# Statement of Reasons

## DEFENCE HOUSING AUSTRALIA – LEE POINT MASTER-PLANNED URBAN DEVELOPMENT

### **Altered Proposal**

Figure 2. Altered site layout for Muirhead North

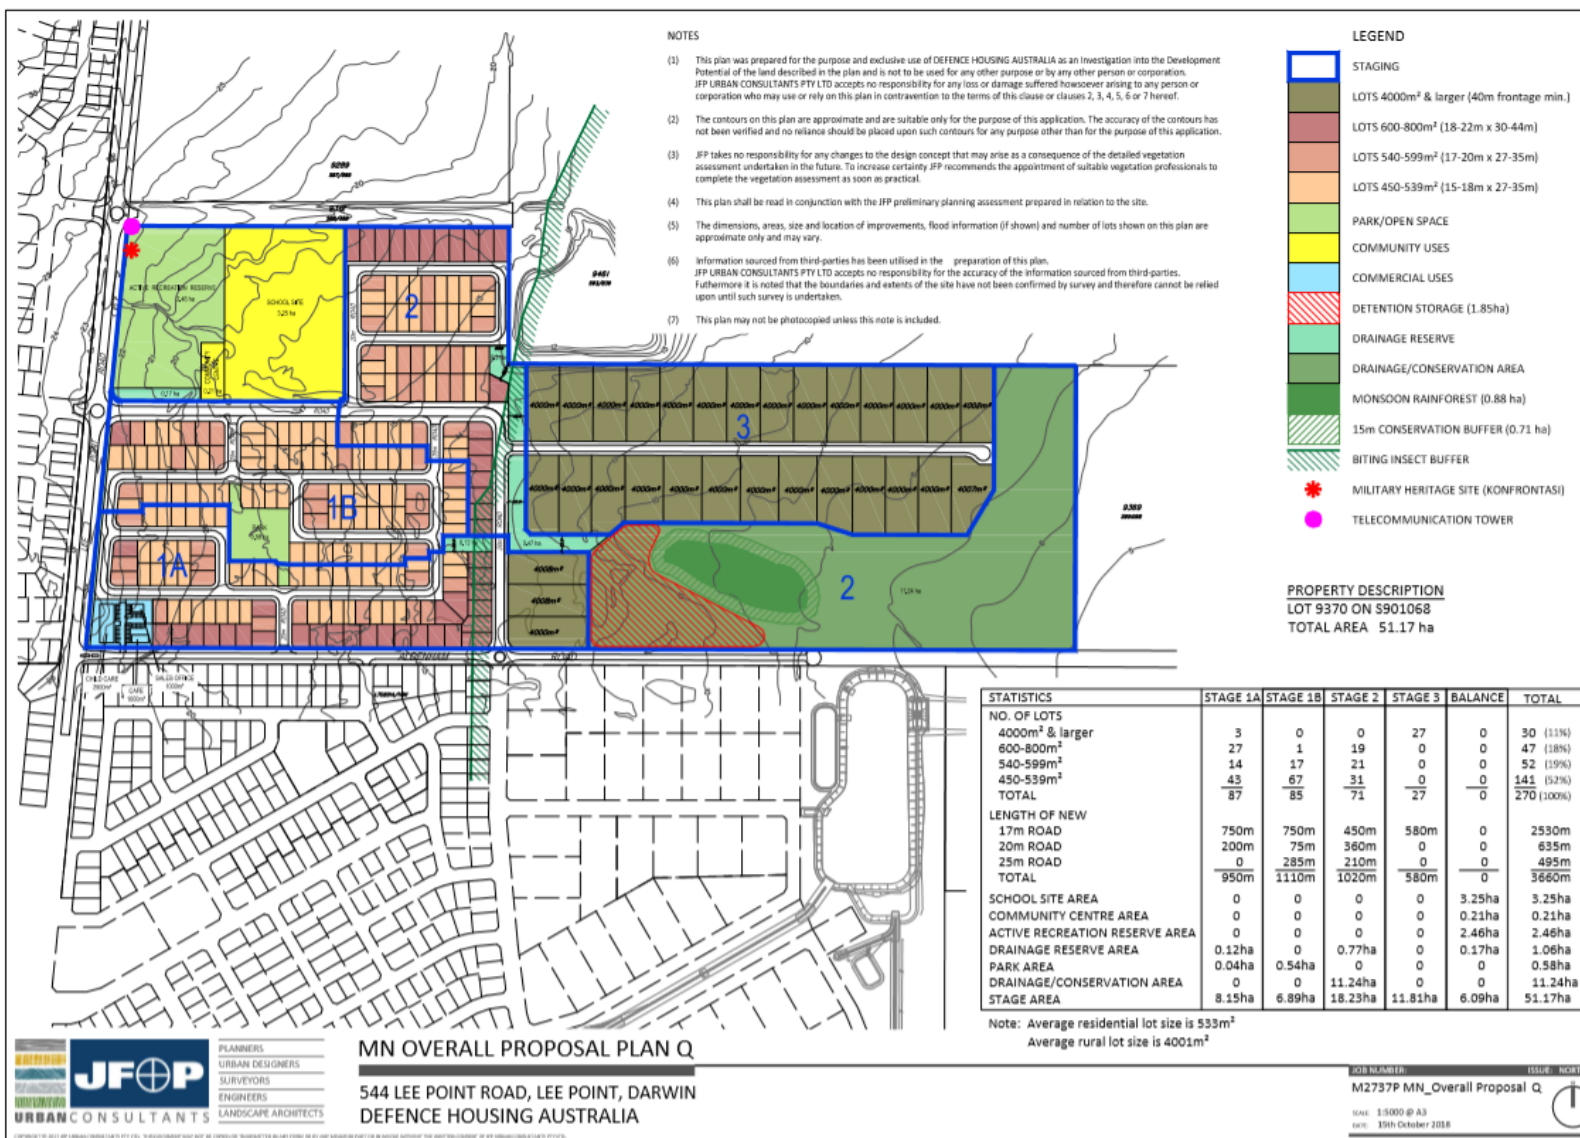
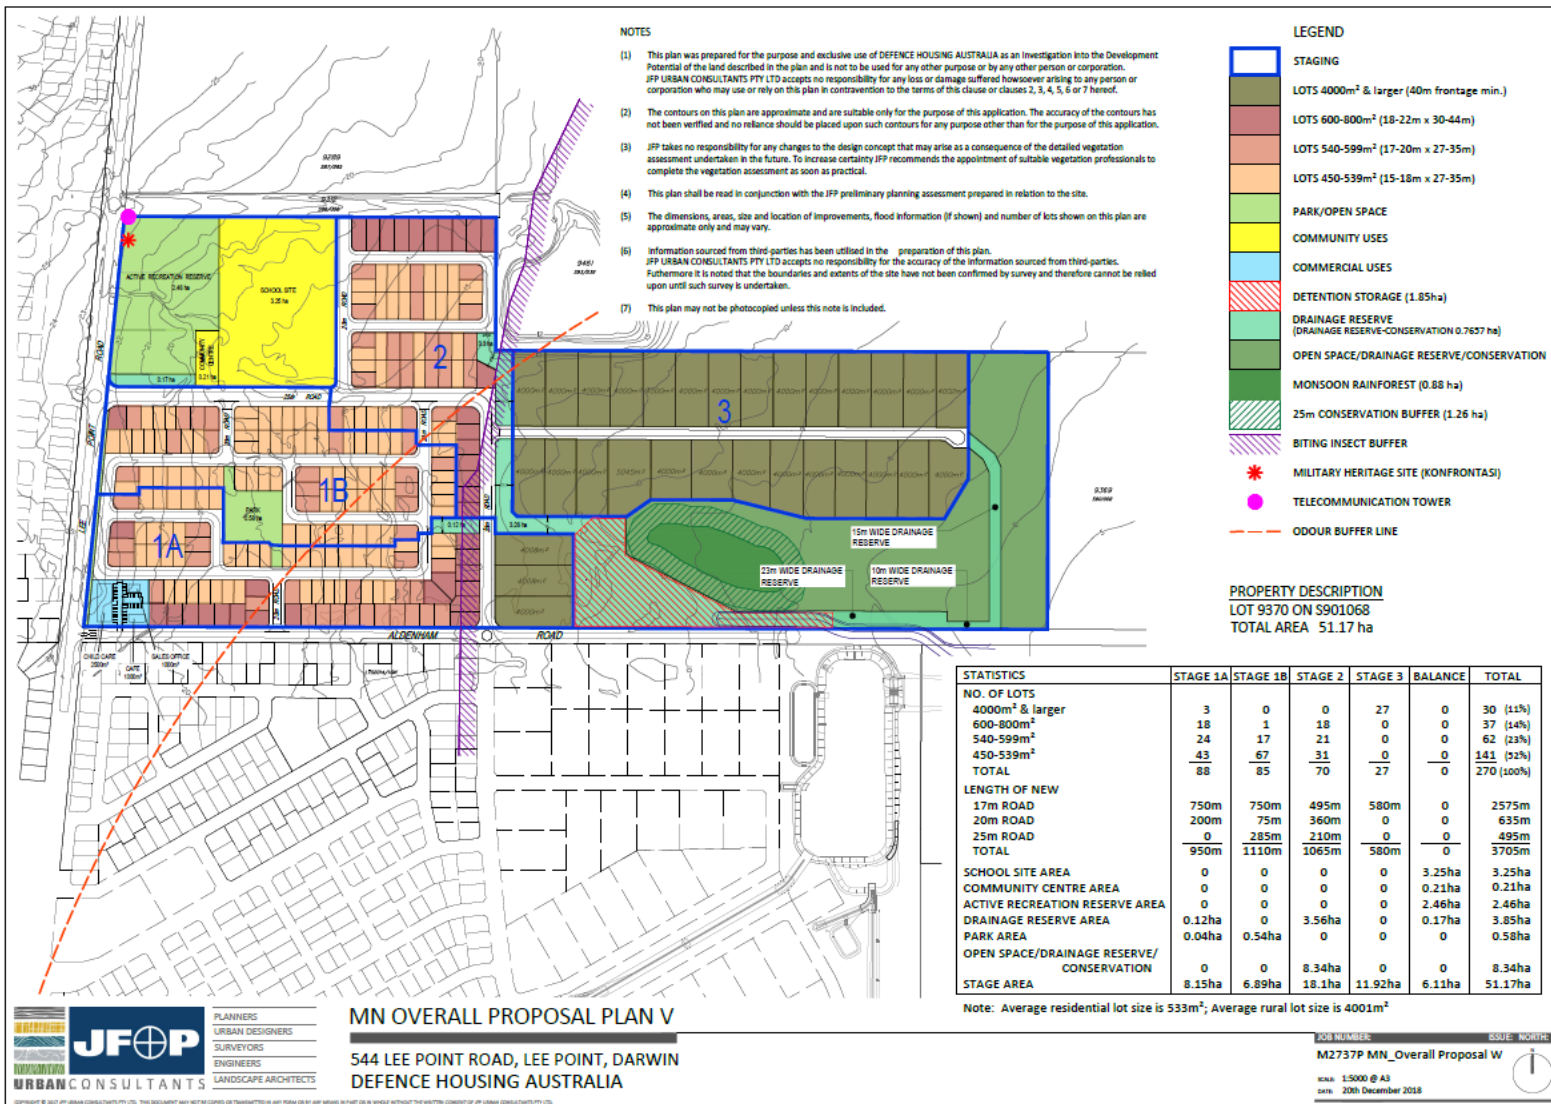
The alteration includes the following changes to the Proposal within Muirhead North (Figure 2):

- altered boundary of the detention storage (to maintain its size while avoiding the larger conservation buffer – see below)
- addition of open-unlined drains and drainage infrastructure (to connect to existing drainage infrastructure at Muirhead for discharge into Buffalo Creek)
- change in proposed zoning to reflect the change in proposed land use in the previously identified 'Drainage Reserve/Conservation Area'
- an increase to the width of the conservation buffer around the 'Monsoon Rainforest' (from 15 m to 25 m in accordance with Recommendation 15 of Assessment Report 88).

The NT EPA acknowledges that the Proposal has been altered from that previously assessed at the level of EIS as outlined in the Proponent's notice. It is acknowledged that the altered Proposal accommodates Recommendation 15 of Assessment Report to impose a 25 m buffer around a patch of monsoon rainforest in Muirhead North. In addition, the notice of alteration includes additional drainage infrastructure not specified in the plan previously considered by the NT EPA.

The notice of alteration proposes new 'Drainage Reserves' in the eastern portion of Muirhead North within an area that contains suitable habitat for *M. g. gouldii*. Based on habitat mapping provided in the Supplement, the NT EPA estimates that the proposed 'Drainage Reserves' would require the clearing of approximately 0.42 ha of suitable habitat for *M. g. gouldii*. The altered 'Detention Storage' is predicted to impact on approximately 1.30 ha of suitable habitat for *M. g. gouldii*.

In addition to the impacts from clearing, the location of the proposed 'Drainage Reserves' may also restrict the species' movement through the site and access to the 'Conservation Area'. Other potential impacts include an increased risk of predation for individuals moving across open areas and degradation of the 'Conservation Area' from edge effects.

The NT EPA acknowledges that the altered Proposal will incrementally increase the significant residual impact on *M. g. gouldii* but notes that there are no new threats or sources of potential impacts beyond those previously considered in Assessment Report 88. The NT EPA considers that the loss of suitable habitat can be compensated through the implementation of Recommendation 14, taking into account the alterations to the Proposal. The residual impact calculations should also take into account the potential impacts from reduced access for *M. g. gouldii*, increased predation potential and degradation of habitat from edge effects.

Recommendation 15 of the NT EPA's Assessment Report would still apply to the altered Proposal, requiring that the 'Open Space/Drainage Reserve/Conservation' at Figure 2 be rezoned as 'Conservation'.

The Proponent proposes to mitigate the predicted increase in flows due to impervious surfaces by using a 1.85 ha detention basin in the southern part of Muirhead North. In altering the boundary of the detention basin to address Recommendation 15 of Assessment Report 88, the Proponent reconsidered the alternatives to attenuate peak flows and ensure the depth of water does not exceed 1.2 m during a 20 year annual recurrence interval event. The Proponent updated the Stormwater Management Plan and included it with the notice of alteration.

This updated Plan predicts that the altered stormwater infrastructure would likely increase peak flows entering the Muirhead North detention basin by 8-12% when compared to the previous stormwater basin design included in the EIS. To accommodate this increase in peak flows, the Proponent has incorporated grass-lined channels to attenuate flows prior to discharging into Buffalo Creek near an existing stormwater outlet for Muirhead. It is also proposed that three of the sporting grounds within the 'Active Recreational Reserve' (in the north west of Muirhead North) are designed to delay flows discharging from 2CRU into Muirhead North.

The NT EPA supports the Proponent's approach to adopting Recommendation 15 with respect to widening the buffer around the monsoon rainforest patch. The NT EPA is satisfied that the environmental significance with respect to the impacts to native vegetation has not changed.

The NT EPA considers that, with the application of recommendations 14 and 15 of Assessment Report 88 to the altered Proposal, the NT EPA's objective for terrestrial flora and fauna can be met.

The NT EPA is satisfied that the reconfiguration of the detention basin and management of stormwaters in the 'Active Recreational Reserve' and grass-lined channels has not changed the environmental significance of the Proposal in relation to hydrological processes.
